Service Bulletin No. 446B

MODEL J4500	TYPE Field Change Program	SECTION/GROUP 3-Body	DATE June 19, 2017
SUBJECT A/C COMPRESSOR SUPPORT TUBE			
CONDITIONS

THIS BULLETIN SUPERCEDES SERVICE BULLETIN 446 IN ITS ENTIRETY.

Figure 34. Addition of shim(s) to achieve a 3/8 inch belt deflection.

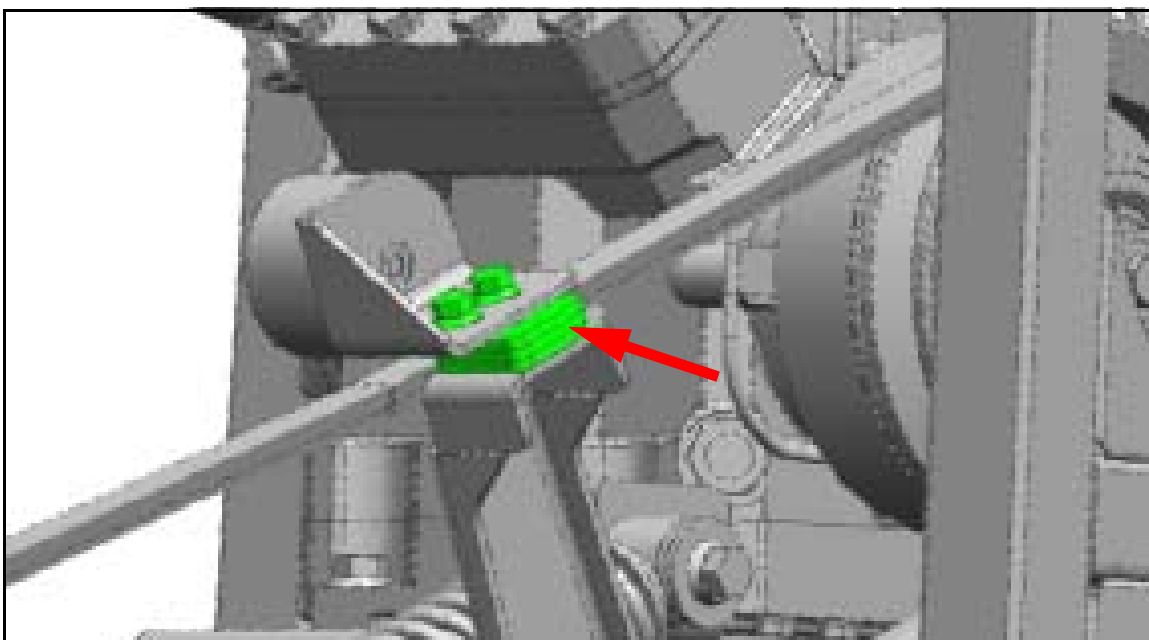
73. Remove the capscrew, p/n 19-01-1570 and lock nut, 19-03-0535 mounting the idler pulley to the snubber bracket. Orient and position the required quantity of shims, p/n 08-27-1324, between the idler pulley bracket and the snubber bracket (refer to Figure 34).
74. Orient and install new capscrews, p/n 19-01-1736, through the idler pulley holes and the shim(s). Install the locknuts, p/n 19-03-0535, on the capscrews. Torque to 43-47 ft-lbs.
